ASB-1011

## Service Bulletin

**Subject:** TM-732A Low Cross-band Repeat Audio

**Date:** May 3, 1993

**X57-4000-11 C/4**  
**Foil Side View**

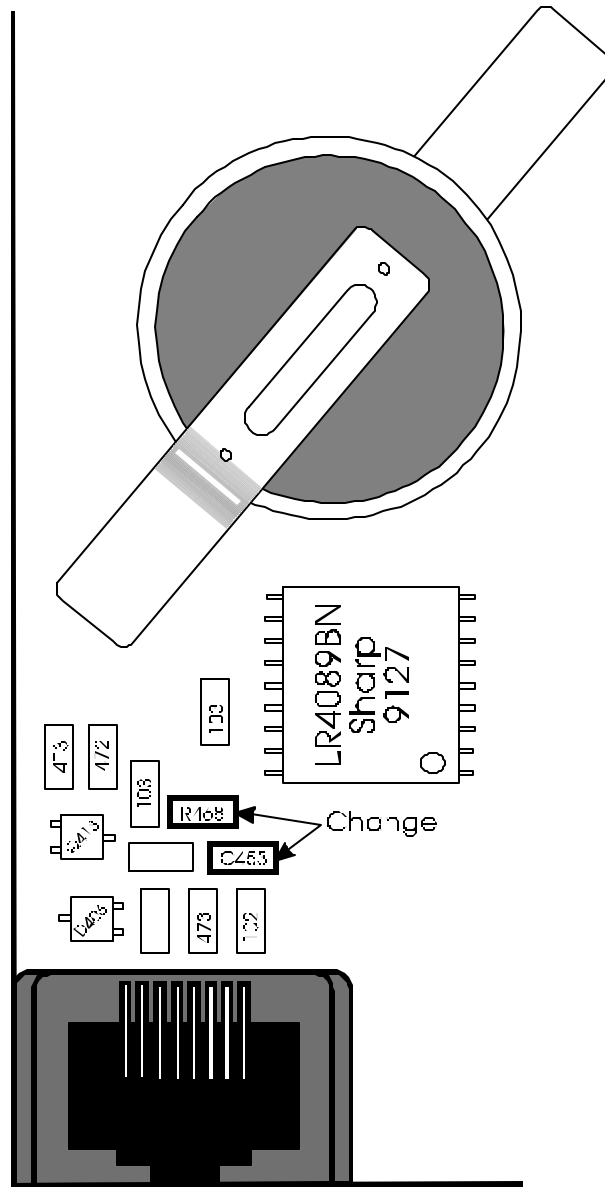
Improper DTMF operation and low microphone audio have been reported by several owners of the TM-732A when the units are operated in the Cross-band repeat mode.

1. Detach the front panel assembly from the chassis.
2. Remove the top and bottom covers from the chassis.
3. Remove the small countersunk Phillips head screws from the sides of the chassis. These are used to secure the two brackets that holds the plastic front cover to the chassis. Gently pull the plastic cover assembly forward and remove it from the chassis.
4. The TX/RX Control unit should now be visible on the front of the chassis assembly.
5. Replace R468 and C453 shown in the accompanying diagram.
6. Reverse steps 1 through 3 to reassemble the radio.

| <u>Qty</u> | <u>Description</u>    | <u>Kenwood Part No.</u> | <u>Circuit Reference</u> |
|------------|-----------------------|-------------------------|--------------------------|
| 1          | 39 Kohm chip resistor | RK73FB2A393J            | R468                     |
| 1          | .01 uF chip capacitor | CK73FB1E103K            | C453                     |
